**Economic and Social Council**Distr.: General
31 January 2019

Economic Commission for Europe**Inland Transport Committee****World Forum for Harmonization of Vehicle Regulations****Working Party on Lighting and Light-Signalling****Eighty-first session**

Simplification of lighting and light-signalling UN Regulations**Proposal for a new [07] series of amendments to UN
Regulation No. 48 (Installation of lighting and light-signalling
devices)****Submitted by the Informal Working Group on Simplification of
Lighting and Light-Signalling Regulations (IWG SLR)***

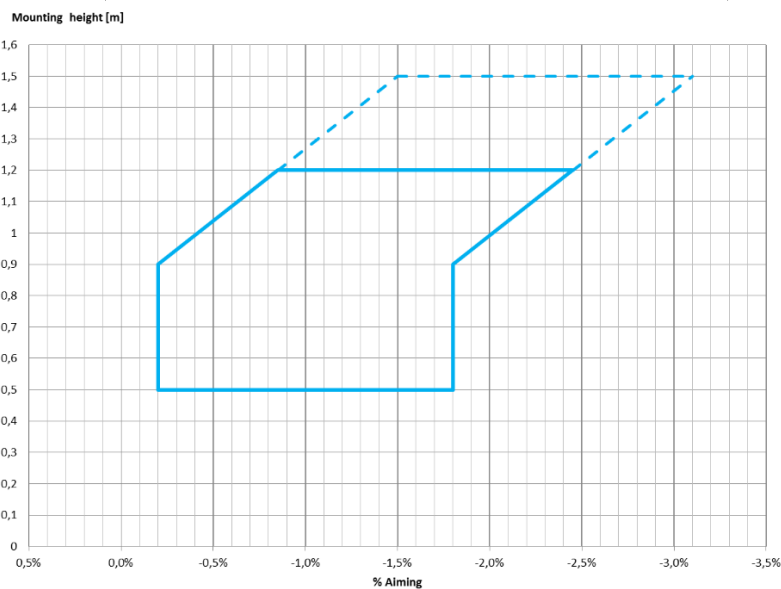
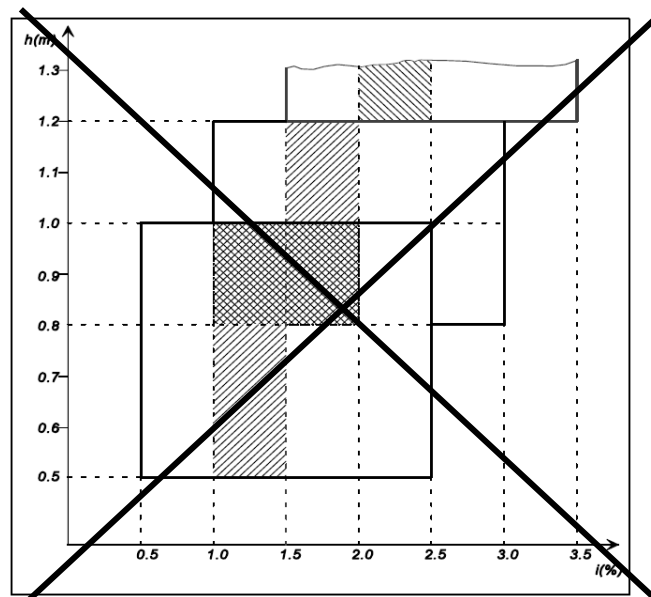
- 6.2.6.1.2. Depending on the mounting height in metres (h) of the lower edge of the apparent surface in the direction of the reference axis of the dipped-beam headlamp, measured on the unladen vehicles, the vertical inclination of the cut-off of the dipped beam, **starting from the initial inclination value set by the vehicle manufacturer as prescribed in paragraph 6.2.6.1.1. above,** shall ~~under all the static conditions of Annex 5,~~ remain between the following limits, **under all the stating loading conditions of Annex 5:**

for $0.5\text{ m} < h < 0.9\text{ m}$, between:

-0.2 % and -1.8 %;

for $0.9\text{ m} < h < 1.2\text{ m}$, between:

the minimum vertical inclination limit increasing linearly, in relation to the dipped-beam headlamp mounting height,

from - 0.2 % to - 0.8[5] %

the maximum vertical inclination limit increasing linearly, in relation to the dipped-beam headlamp mounting height,

from - 1.8 % to - 2.4[5] %;

~~[For In the case of category N₃G (off-road) vehicles: , where the headlamps exceed a height of 1,200 mm the limits for the vertical inclination of the cut off shall be between: 1.5 per cent and 3.5 per cent for 1.2 m < h < 1.5 m, between:~~

the minimum vertical inclination limit increasing linearly, in relation to the dipped-beam headlamp mounting height, from - 0.8[5] % to - 1.5 %

the maximum vertical inclination limit increasing linearly, in relation to the dipped-beam headlamp mounting height, from - 2.4[5] % to - 3.1 %.

The above limits ~~and the initial aiming values~~ are summarized in the diagram below.

10. The range of vertical orientation has been modified based on the IWG VGL decisions. IWG VGL decided to present a proposal in which this range is from 0% to -1.6 %; it was also agreed that, if requested by GRE Experts, the 0 % limit will be moved to the -0.2 % limit maintaining the 1.6 % range (i.e. shifting in parallel the upper limit to -1.8 %). The United Kingdom of Great Britain and Northern Ireland (UK) and Poland requested the International Organization of Motor Vehicle Manufacturers (OICA) to provide better justifications for the need to have a range at least 1.6 % wide.

11. At the seventy-eighth session of GRE, some experts requested to shift the 0 % limit to -0.2 % and nobody opposed the parallel shifting of the -1.6 % limit to -1.8 % limit. UK and Poland reiterated their request for better justification for the need to have a range at least 1.6 % wide.

12. As far as the range of vertical orientation for N3G category vehicles having headlamps installed at more than 1.2 m from the ground is concerned, IWG VGL did not take any decision, even if the idea to follow the same parameters used for the other vehicles categories was discussed. The proposed values are then put in square brackets; in any case they provide an improvement, from illumination distance point of view, in respect to the present requirements.

13. Finally, among the proposed orientation limit values, two of them should have, from calculation, two digits after the coma, while only one digit after the coma is indicated in the present text of UN Regulation No. 48. Consequently, the second digit is always indicated in square brackets, to decide whether to maintain it or round the first digit to the nearest value.

Model A

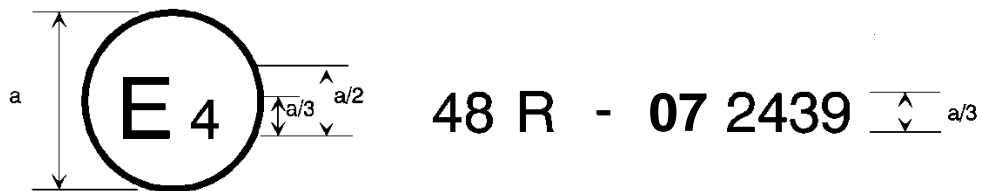
The above approval mark affixed to a vehicle shows that the vehicle type concerned has, with regard to the installation of lighting and light-signalling devices, been approved in the Netherlands (E 4) pursuant to Regulation No. 48 as amended by the ~~06~~ [07] series of amendments. The approval number indicates that the approval was granted in accordance with the requirements of Regulation No. 48 as amended by the ~~06~~ [07] series of amendments.

19. This annex is amended to update the marking examples and related description to the introduction of the 07 series of amendments.

Model B

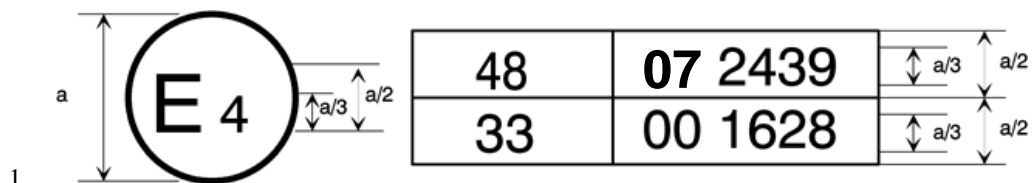
The above approval mark affixed to a vehicle shows that the vehicle type concerned has been approved in the Netherlands (E 4) pursuant to Regulation No. 48 as amended by the ~~06~~ [07] series of amendments and Regulation No. 33.^[1] The approval number indicates that, at the dates when the respective approvals were given, Regulation

No. 48 was amended by the 06 [07] series of amendments and Regulation No. 33 was still in its original form.
